**SECTION 009112  
ADDENDUM NUMBER 2**

**PROJECT: UCA CAMPUS DISTRICT LOOP & CHILLER PLANT**

**PROJECT NUMBER: 48879**

**ROOF FRAMING PLAN**  
1/4" = 1'-0"

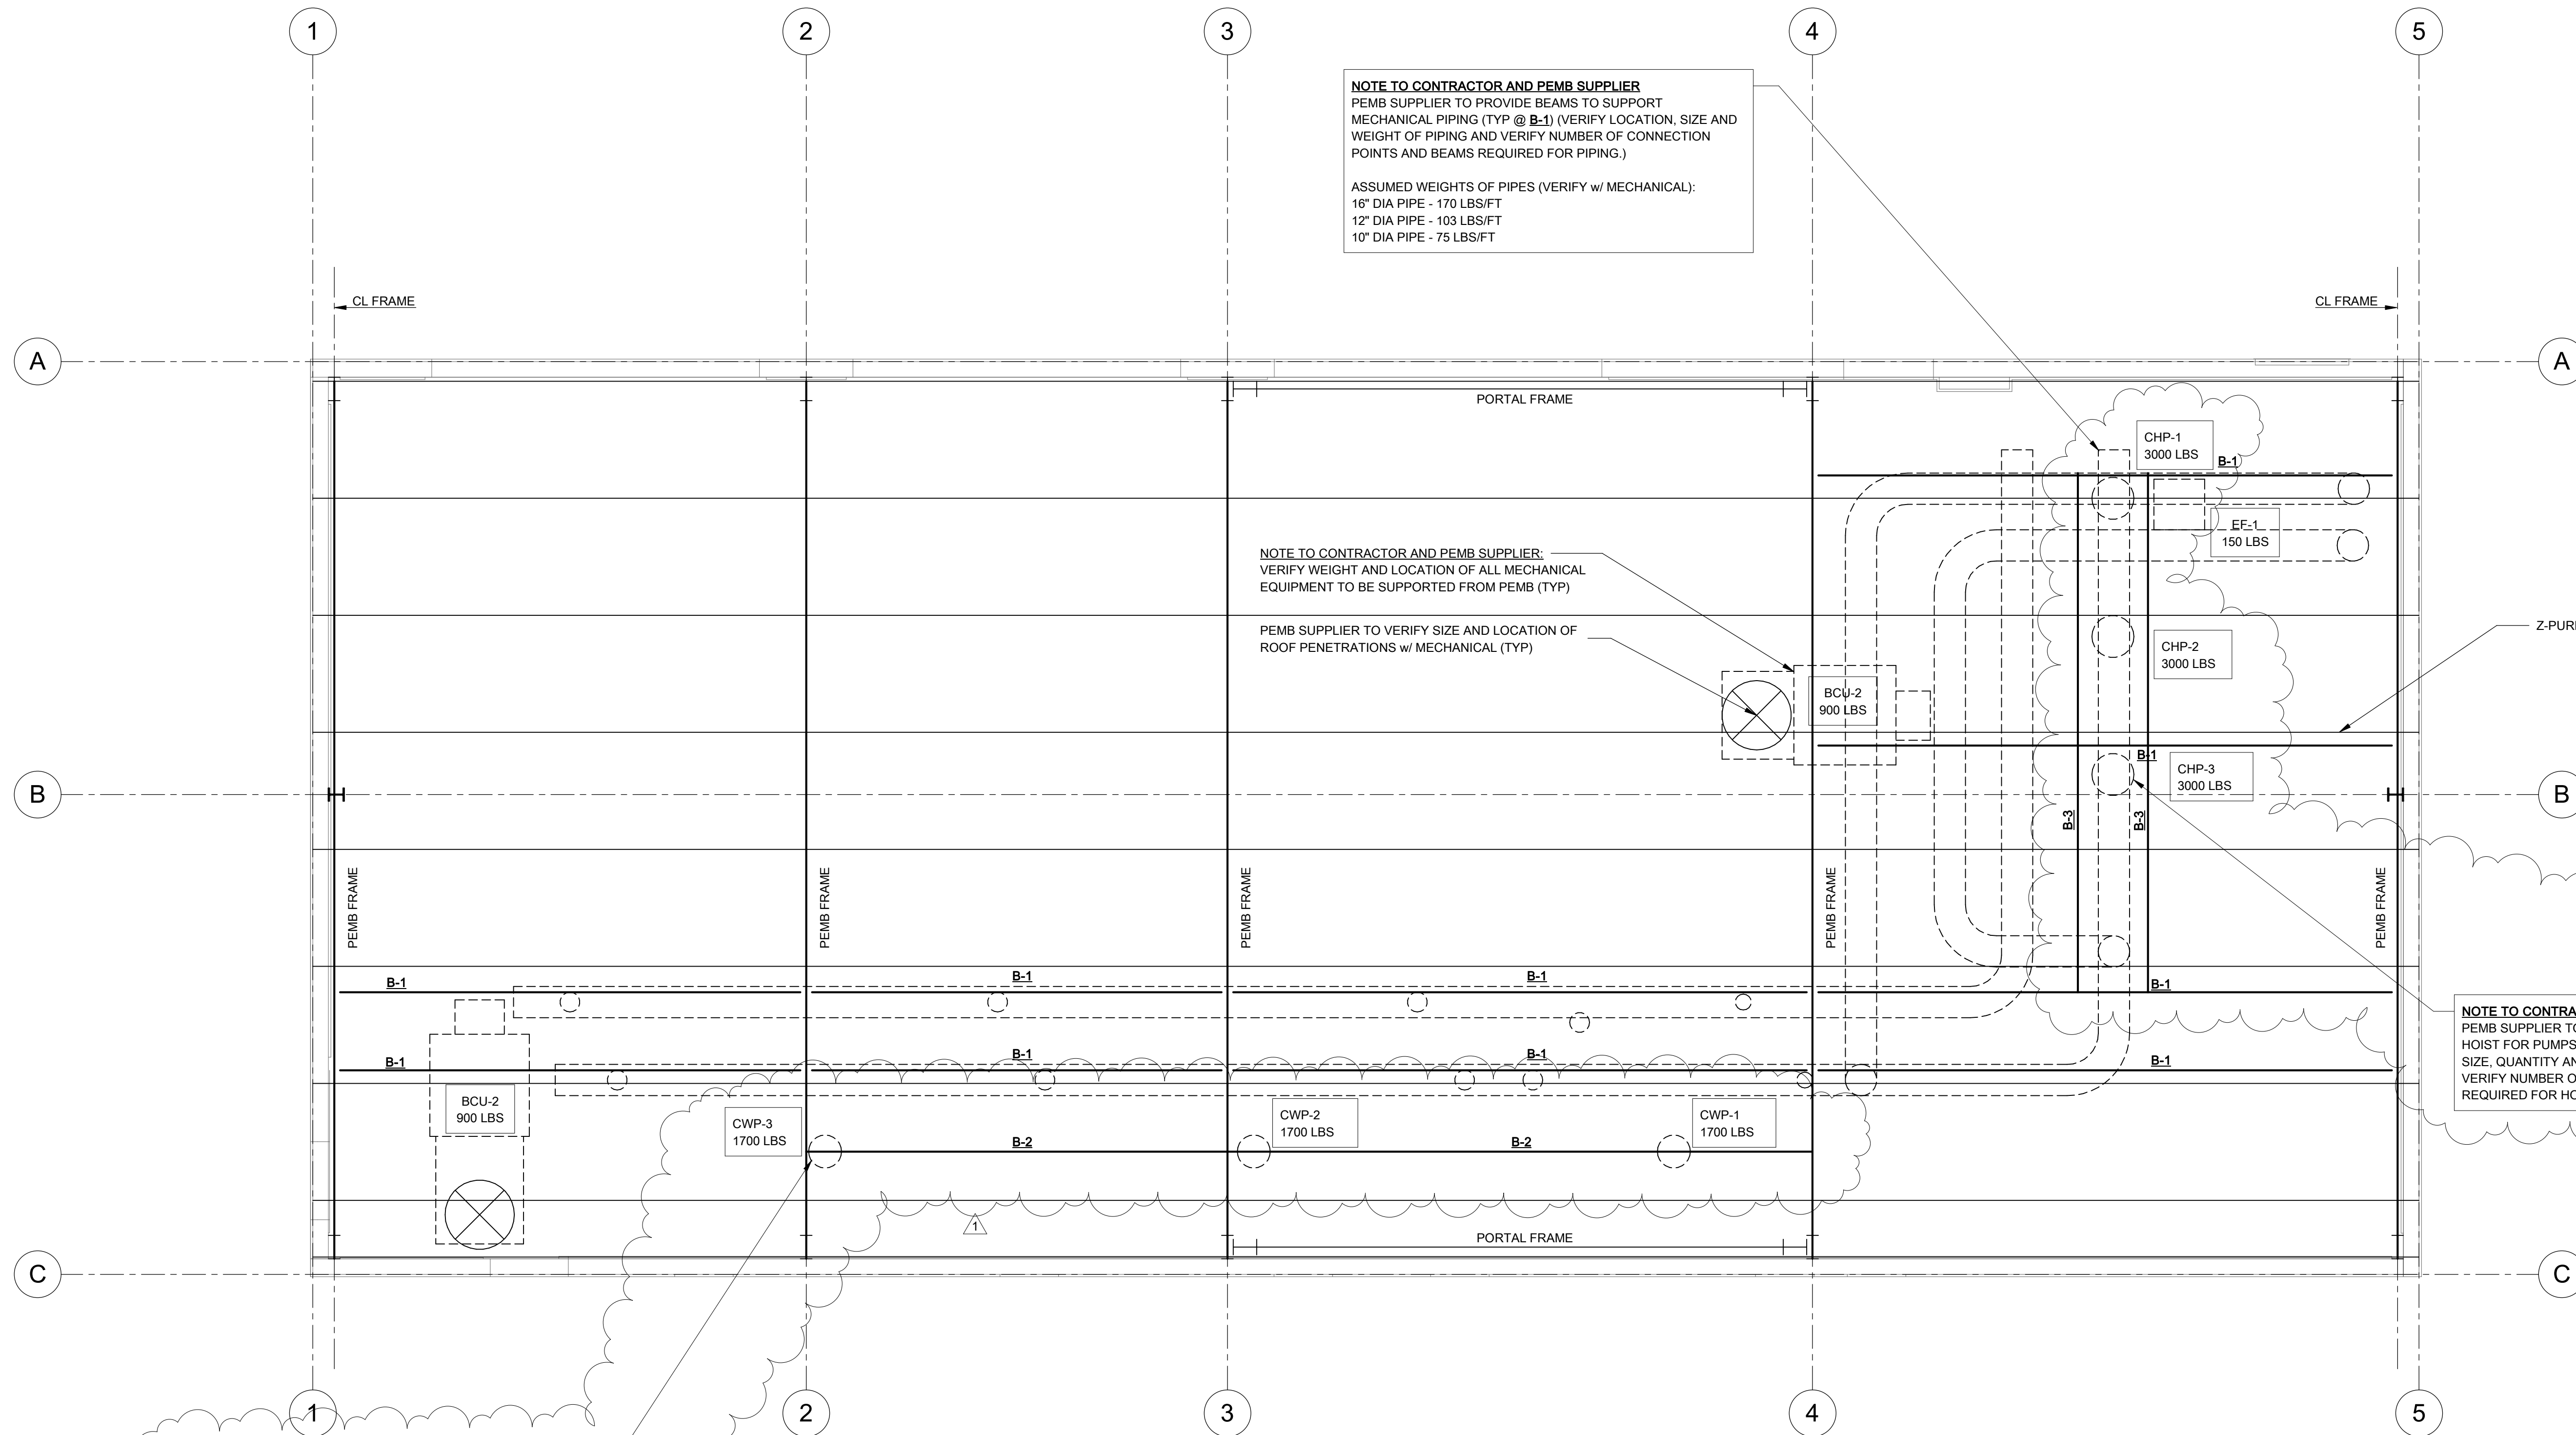
**NOTE TO CONTRACTOR AND PEMB SUPPLIER**  
PEMB SUPPLIER TO PROVIDE BEAMS TO SUPPORT MECHANICAL PIPING (TYP @ B-1) (VERIFY LOCATION, SIZE AND WEIGHT OF PIPING AND VERIFY NUMBER OF CONNECTION POINTS AND BEAMS REQUIRED FOR PIPING.)

**NOTE TO CONTRACTOR AND PEMB SUPPLIER**  
PEMB SUPPLIER TO PROVIDE BEAMS (TYP @ B-3) TO SUPPORT HOIST FOR PUMPS (CHP @ (3) PLACES) (VERIFY LOCATION, SIZE, QUANTITY AND WEIGHT OF PUMPS w/ MECHANICAL AND VERIFY NUMBER OF CONNECTION POINTS AND BEAMS REQUIRED FOR HOIST w/ MECHANICAL AND OWNER)

**NOTE TO CONTRACTOR AND PEMB SUPPLIER**  
PEMB SUPPLIER TO PROVIDE BEAMS (TYP @ B-2) TO SUPPORT HOIST FOR PUMPS (CWP @ (3) PLACES) (VERIFY LOCATION, SIZE, QUANTITY AND WEIGHT OF PUMPS w/ MECHANICAL AND VERIFY NUMBER OF CONNECTION POINTS AND BEAMS REQUIRED FOR HOIST w/ MECHANICAL AND OWNER)

## 1 SOUTH PLANT FLOOR PLAN - HVAC DEMO

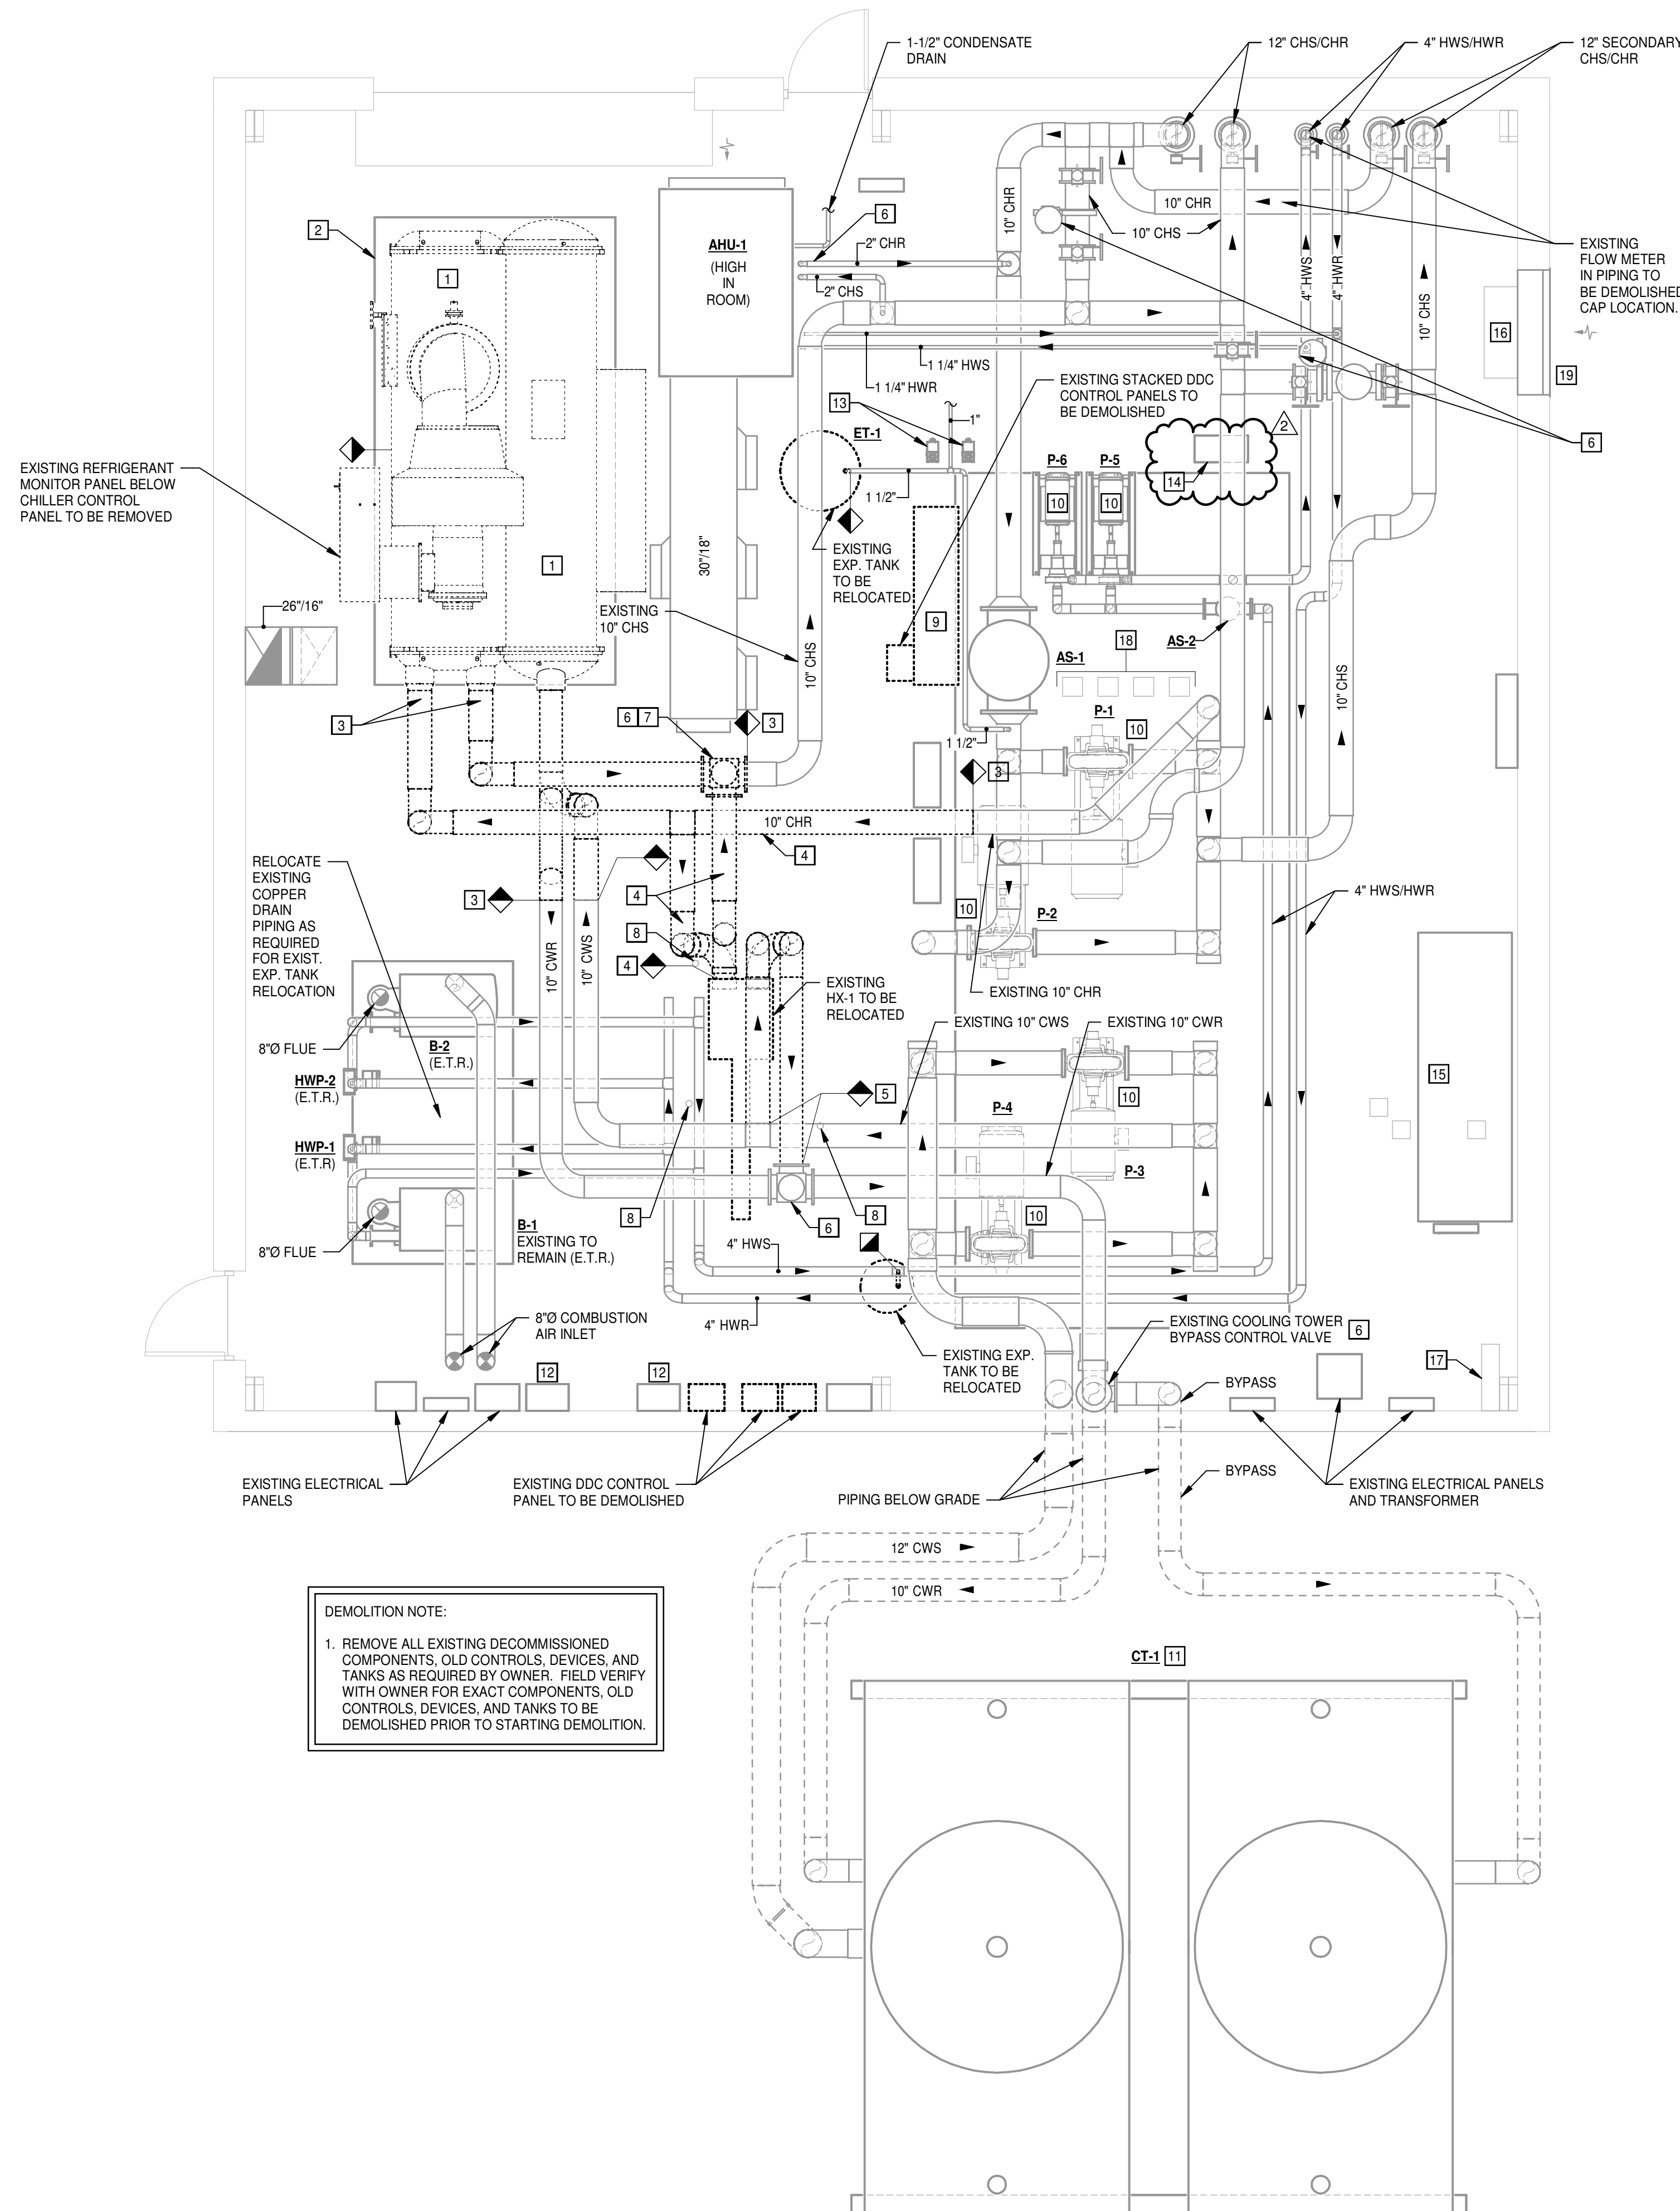
- A1. REFER TO SHEET M001 – DELETED THE MOVING OF THE EXISTING HEATING WATER CONTROL SYSTEM PANEL AS NOTED BY KEYED NOTE 14. THE EXISTING HEATING WATER CONTROL SYSTEM PANEL WILL REMAIN IN ITS CURRENT LOCATION. CHANGE KEYED NOTE 14 TO READ, “EXISTING HEATING WATER SYSTEM CONTROL PANEL TO REMIAN.”
- A2. REFER TO SHEET M101 – ADDED A NEW CONTROL SYSTEM GLOBAL CONTROLLER PANEL ADJACENT TO THE BUILDING CONTROL SYSTEM NOTED BY KEYED NOTE 35. CHANGED AIR SEPARATOR AS-1 TO SPIROTHERM MODEL 14 VDN.
- A3. REFER TO SHEET M103 – INDICATED THAT THE EXISTING HEATING WATER CONTROL SYSTEM PANEL SHALL REMAIN IN THE EXISTING LOCTION. DELETED RELOCATION OF EXISTING HEATING WATER CONTROL SYSTEM PANEL TO SOUTH WALL OF SOUTH PLANT.
- A4. REFER TO SHEET M606 – REVISED KEYED NOTES TO ADD A FLOW METER AND REVISED CONTROL DIAGRAM FOR CONTROL OF MAKE-UP WATER SYSTEM FLOW.

**1 FIRST FLOOR PLAN - POWER**  
 SCALE: 1/4" = 1'-0"

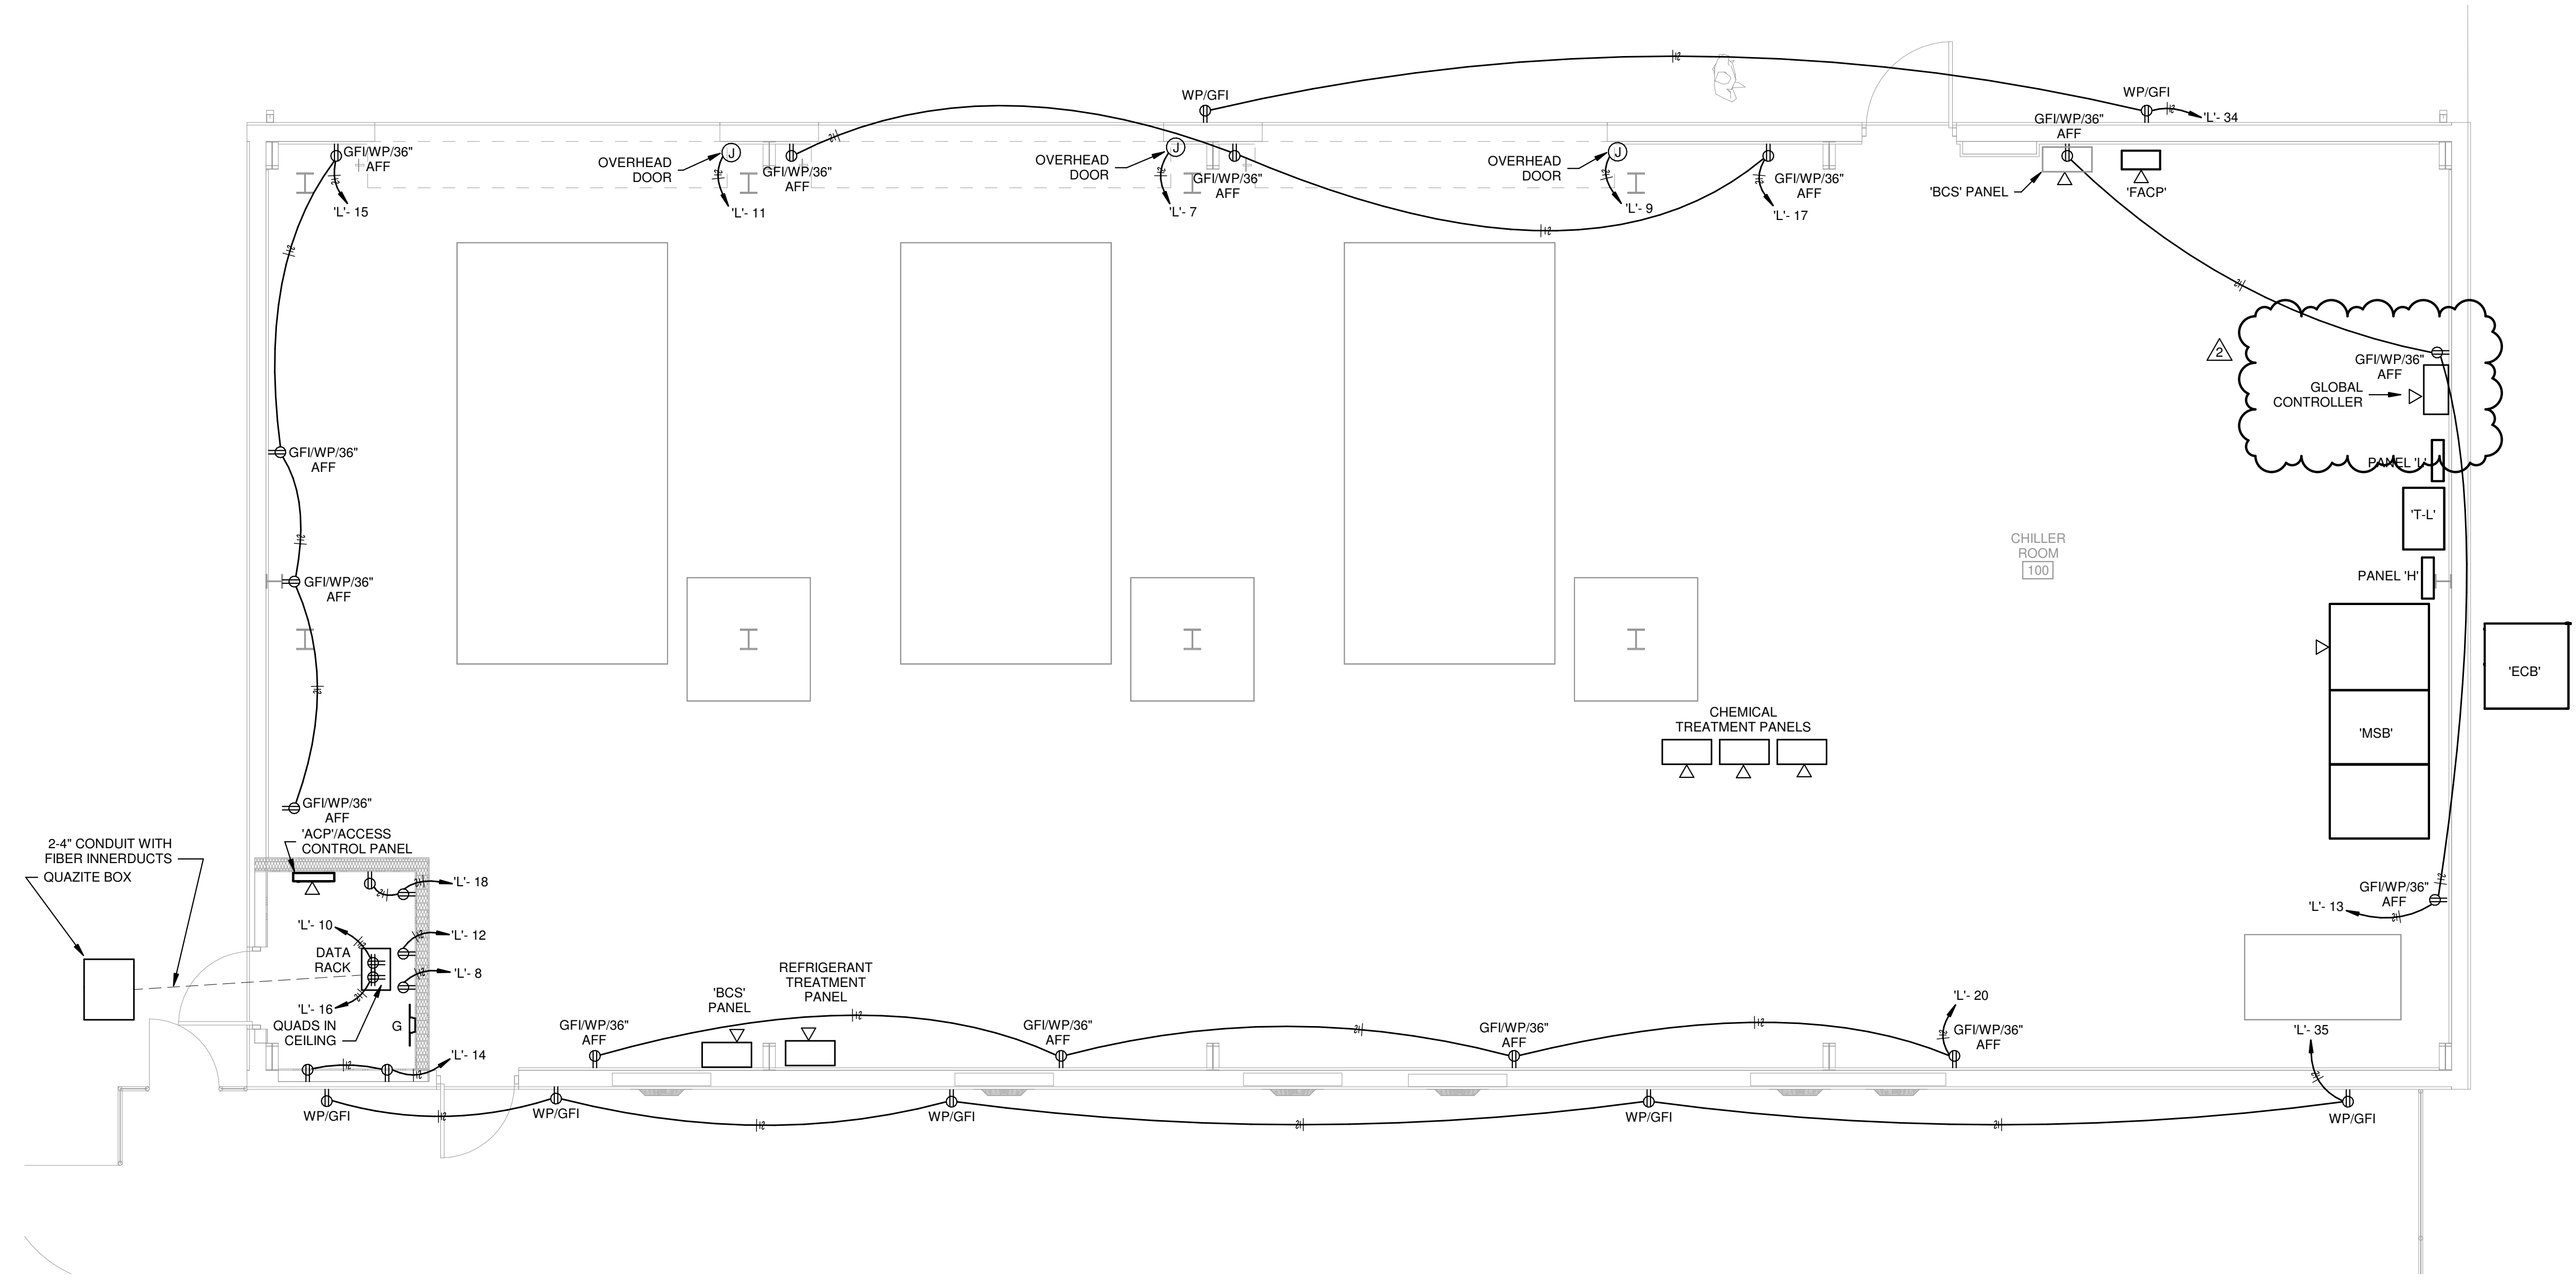
- A5.** REFER TO SHEET E102 – NORTH PLANT PLAN – POWER
  - a. ADDED DATA FOR GLOBAL CONTROLLER
- A6.** REFER TO SHEET E103 – NORTH PLANT PLAN - SYSTEMS
  - a. ADDED POWER FOR GLOBAL CONTROLLER.
- A7.** REFER TO SHEET E201 – ELECTRICAL PANEL & RISER - NORTH PLANT:
  - a. MODIFIED NOTE #1 ON DATA RISER DIAGRAM
  - b. MODIFIED NOTE #5 ON POWER SYSTEM RISER DIGARM – NORTH PLANT.
- A8.** REFER TO SHEET E301 – ELECTRICAL PANELS – NORTH PLANT
  - a. REVISED NOTES FOR POWER METER
  - b. REMOVED BREAKER SHOWN ON ELEVATION
- A9.** REER TO SHEET E302 – ELECTRICAL PANELS – NORTH PLANT:
  - a. ADDED BREAKER FOR GLOBAL CONTROLLER CIRCUIT (L-40)
- A10.** REFER TO SHEET E401 – SOUTH PLANT PLAN – ELECTRICAL
  - a. EXISTING NWC CONTROL PANEL WILL REMAIN IN SAME LOCATION; REMOVED KEYED NOTE ASSOCIATED WITH RELOCATED CONTROL PANEL. FOR REFERENCE, SHOWING EXISTING LOCATION.
  - b. REVISED KEYED NOTE #2.
